ALLEGHENY COUNTY SANITARY AUTHORITY

CONTRACT NO. 1729 G, E, H, P

EAST HEADWORKS

ADDENDUM NO. 7

ALLEGHENY COUNTY SANITARY AUTHORITY

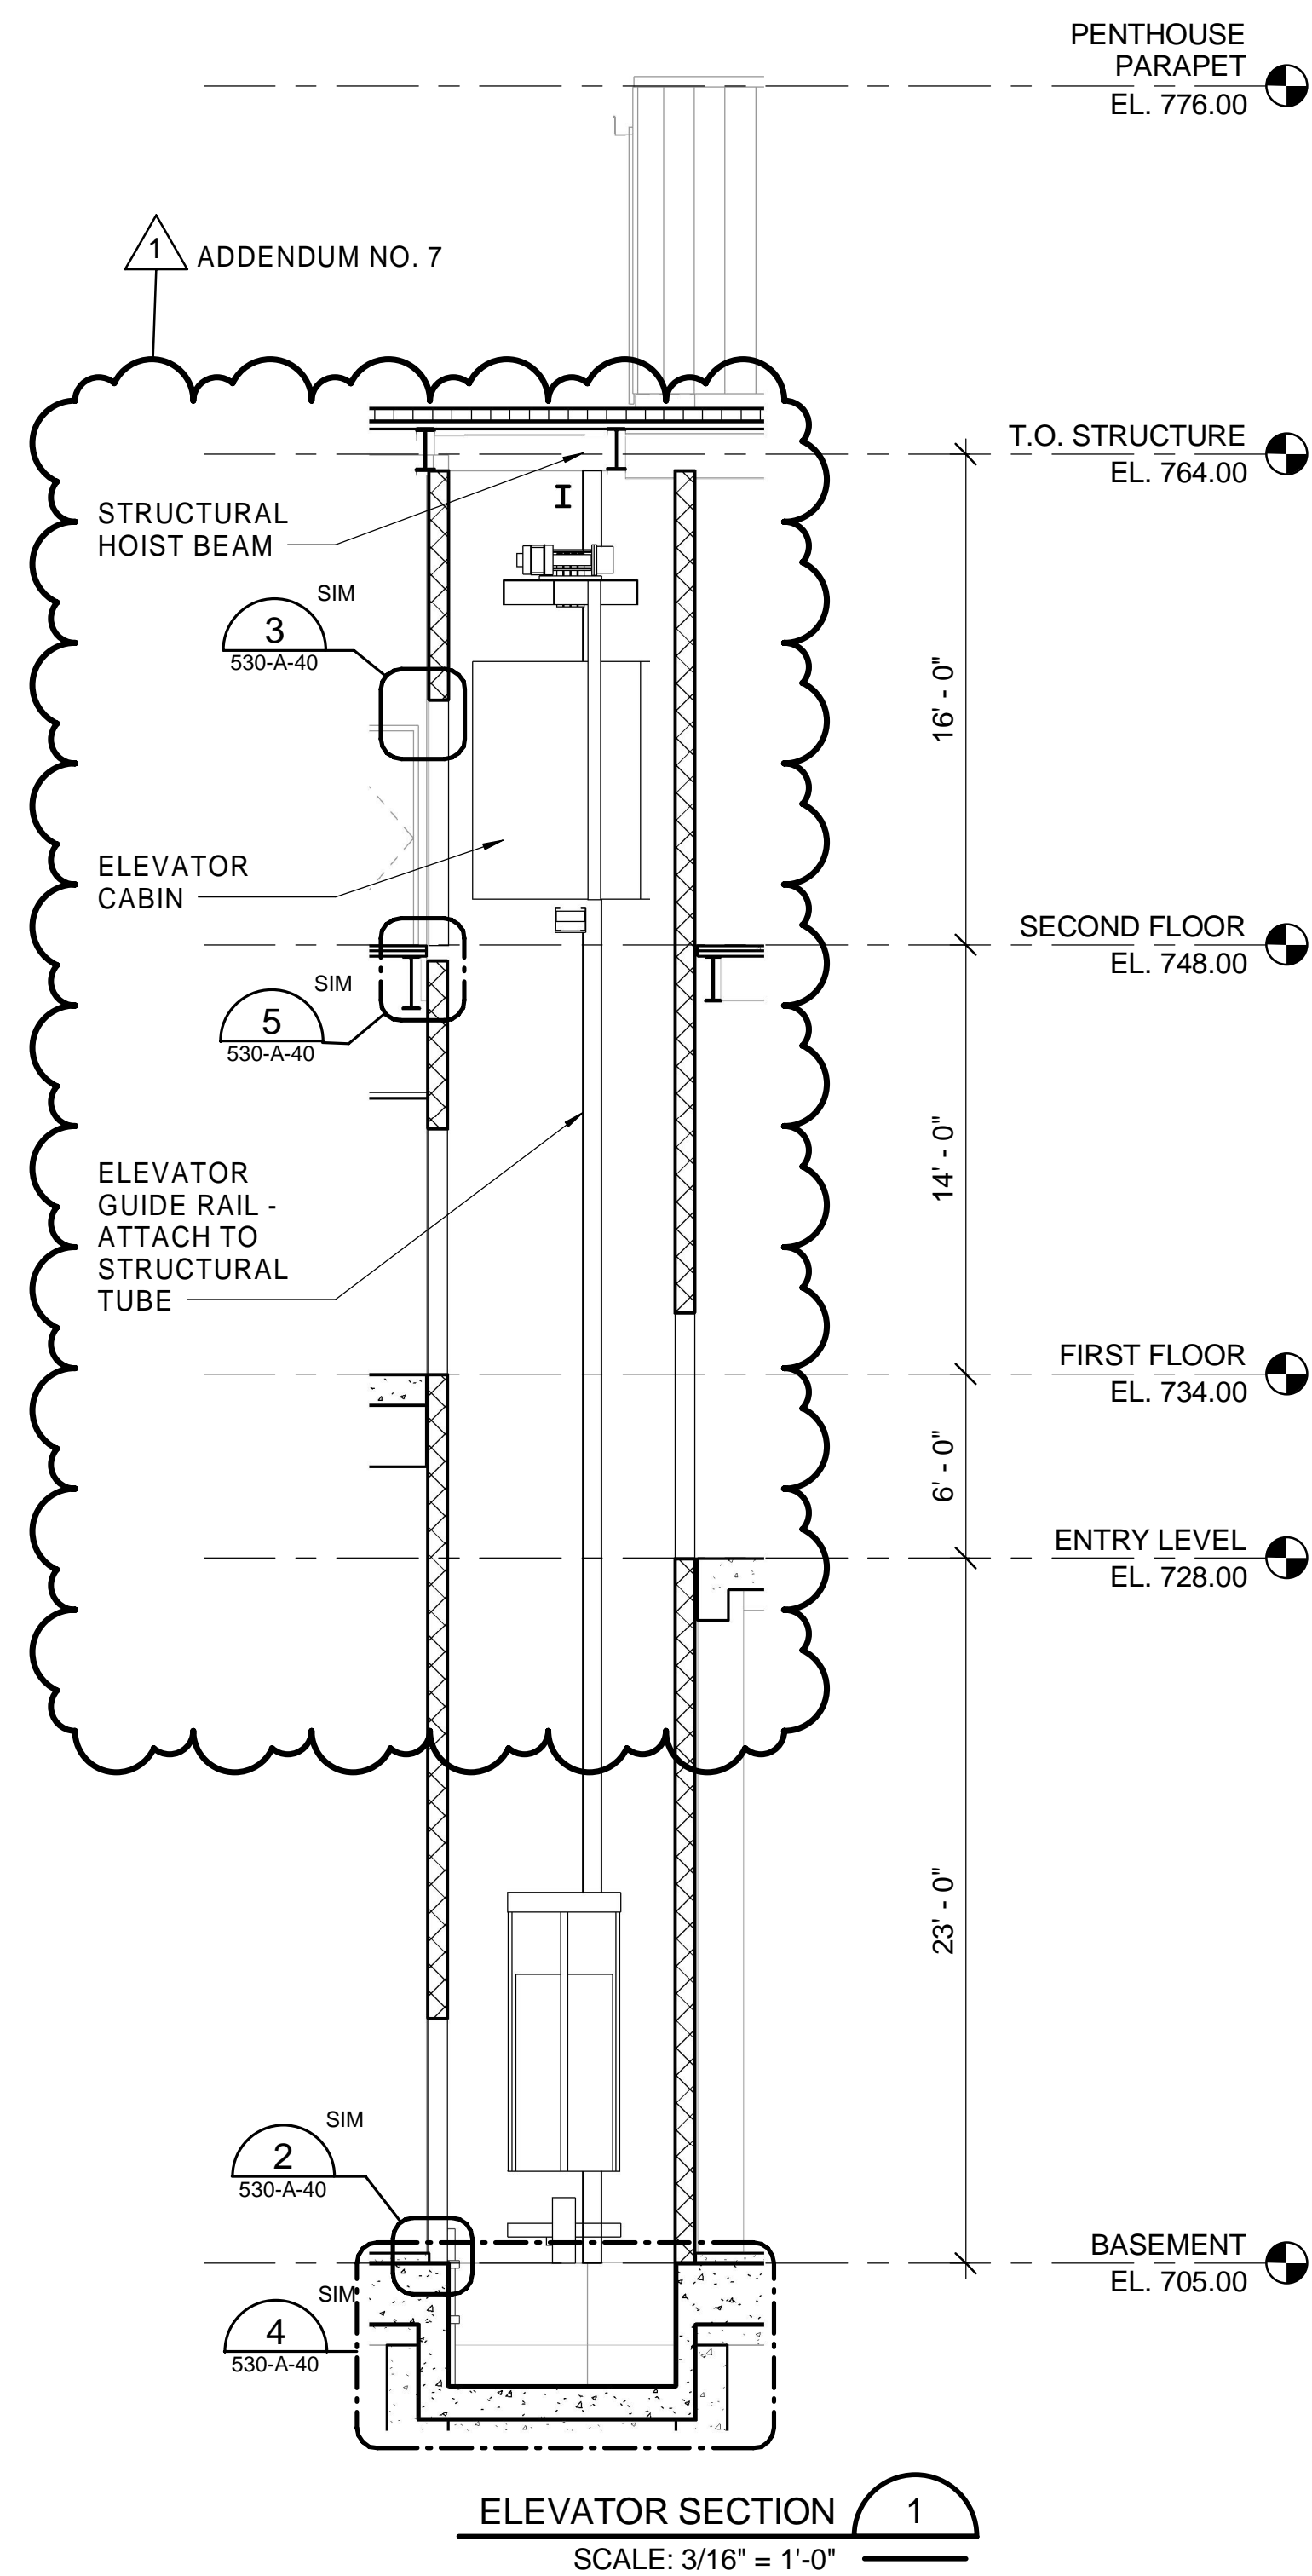
133. **QUESTION:** Reference drawing 530-A-37 (102 of 645), in section 1 for Stair 2 there are 2ea detail call outs numbered 1 and 3 from drawing 530-A-38 located near the top of the section view. On drawing 530-A-38 detail 1 and detail 3 are for railing details where there is not railing shown on 530-A-37. Also reference drawing 530-ELP-10 which shows the stairs extending to uppermost level of stair 2 as opposed to 530-A-37. It appears that drawing 530-A-37 may have been issued incorrectly and that the intent was to extend the stairs all the way to the top of the stairwell as indicated in 530-ELP-10. Please advise.

RESPONSE: The uppermost level of the stair was omitted from the drawing. The intent is for Stair 2 to terminate at the Penthouse Floor Level (Elevation 766). Refer to revised drawings 530-A-23, 530-A-28, and 530-A-36 through 39, issued with Addendum No. 7.
